ATTACHMENT B

MARKED UP PAGES FOR
PROPOSED CHANGES TO APPENDIX A
TECHNICAL SPECIFICATIONS OF
FACILITY OPERATING LICENSES
NPF-72 AND NPF-77

BRAIDWOOD STATION UNIT 1
REVISED PAGES:

EVALUATION OF SIGNIFICANT HAZARDS CONSIDERATIONS FOR PROPOSED CHANGES TO APPENDIX A TECHNICAL SPECIFICATIONS OF FACILITY OPERATING LICENSES NPF-72 AND NPF-77

FIGURE 3.4-4a
NOMINAL PORV PRESSURE RELIEF SETPOINT VERSUS
RCS TEMPERATURE FOR THE COLD OVERPRESSURE PROTECTION SYSTEM
APPLICABLE UP TO 5.37 EFPY (UNIT 1)

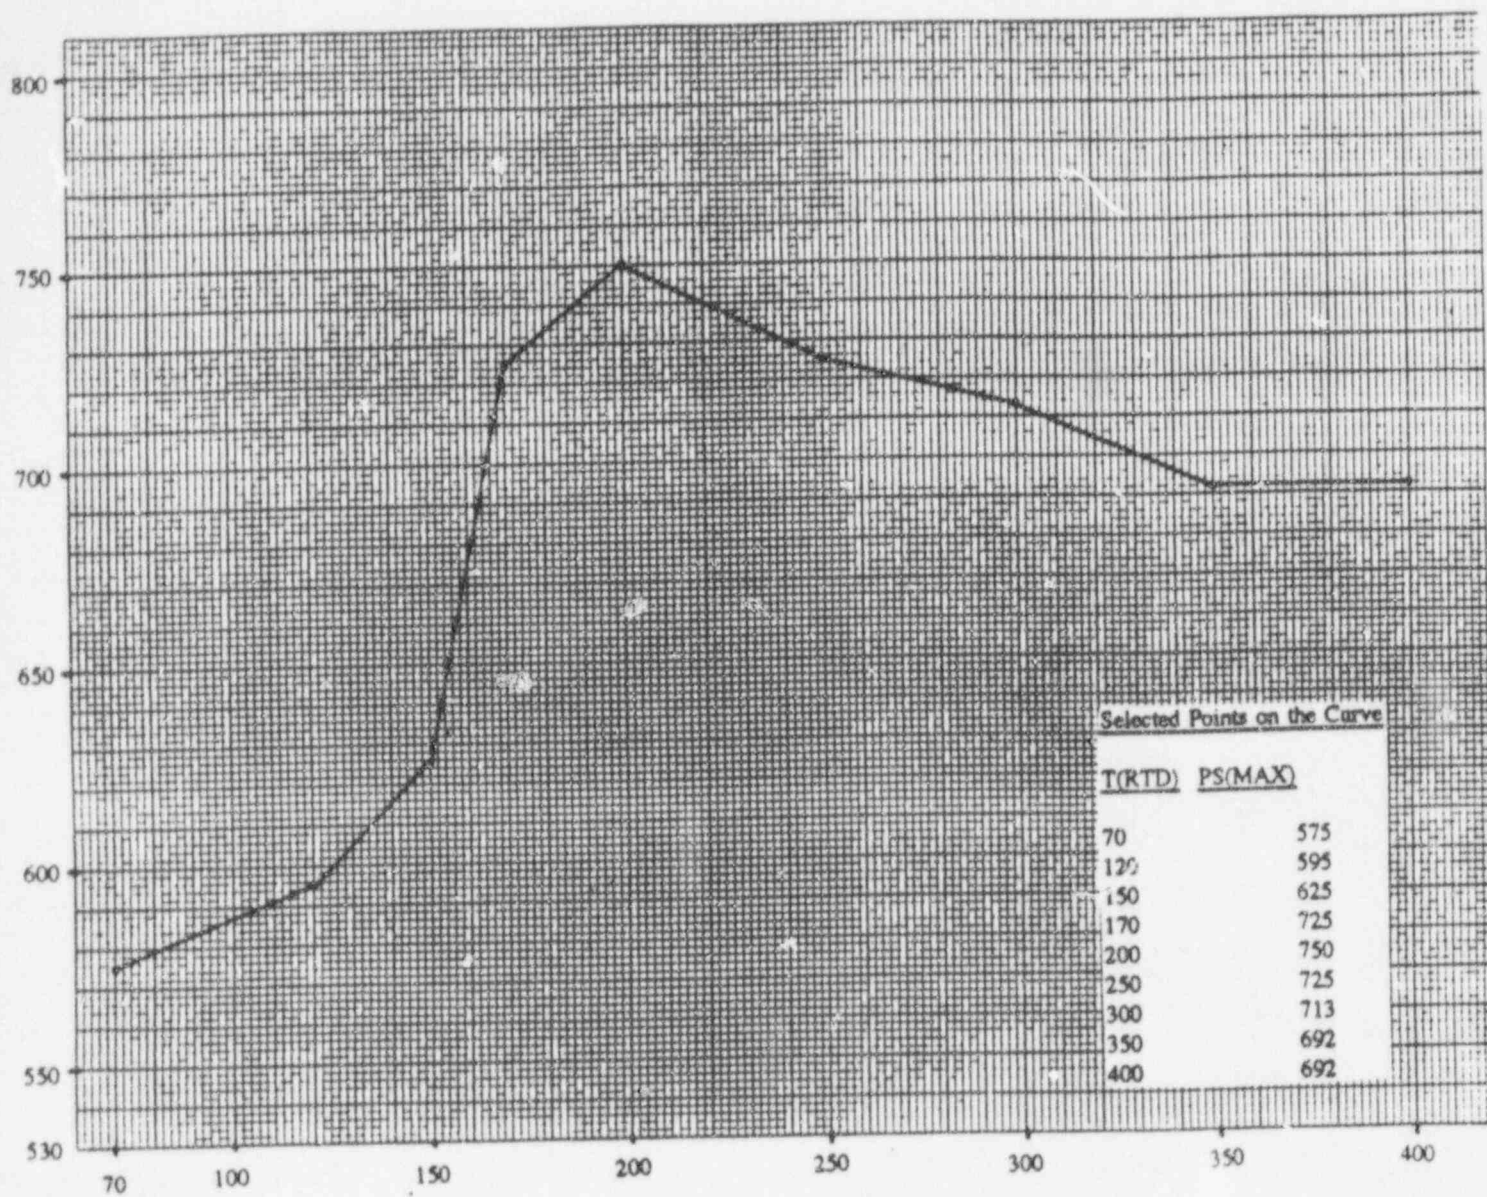
Replace curve with Inset A

Commonwealth Edison (ComEd) proposes to revise Figure 3.4-4a, "Nominal PORV Pressure Relief Setpoint Versus RCS Temperature For The Cold Overpressure Protection System Applicable up to 5.37 EFY (Unit 1)," of Technical Specification 3.4.9.3 and the bases associated with TS 3.4.9.3. The index page entry associated with Figure 3.4-4a will also be changed to reflect the changes in Figure 3.4-4a. Figure 3.4-4a describes the nominal Pressurizer Power Operated Relief Valve (PORV) setpoints for the Low Temperature Overpressure Protection System (LTOPS) as a function of reactor Coolant System (RCS) temperature.

Currently, Figure 3.4-4a is valid until Braidwood Unit 1 reaches 5.37 Effective Full Power Years (EFY). In addition, the current Figure 3.4-4a contains an administrative limit line to protect PORV downstream piping from water hammer effects during pressurizer solid water conditions, and contains allowances for pressure and temperature instrument uncertainties. The current Figure 3.4-4a also contains allowances for a 50°F thermal transport effect associated with the postulated heat injection transient.

In order to extend the duration of applicability for Figure 3.4-4a to 8.5 EFPY, remove the pressure and temperature instrument uncertainties, and remove the administrative limit line it is necessary to revise the current Figure 3.4-4a. The revised Figure 3.4-4a will retain the 50°F thermal transport effect allowance. Additionally, the revised curve accounts for the flow induced pressure difference between the pressure transmitter in the RCS loop piping and the reactor vessel midplane, and takes advantage of a 10% relaxation of the maximum allowable RCS pressure in accordance with American Society of Mechanical Engineers (ASME) Code Case N-514. ComEd applied for permission to use the criteria of ASME Code Case N-514 in the determination of LTOPS setpoints via letter dated November 30, 1994.

INSERT A

Figure 3.4-4a and 3.4-4b are based on this analysis and represent the maximum allowable PORV variable setpoint such that for the overpressurization transients noted, Figure 3.4-4a limits the resulting pressure to 110% of the Appendix G vessel NDT limits, Figure 3.4-4b ensures the resulting pressure will not exceed the Appendix G vessel NDT limits.

Figure 3.4-4a does not contain allowances for random instrument uncertainties and was developed using the guidance contained in ASME Code Case N-514 in addition to the Appendix G requirements. Figure 3.4-4a also accounts for the flow induced pressure difference between the RCS pressure sensor and the Reactor Vessel beltline.
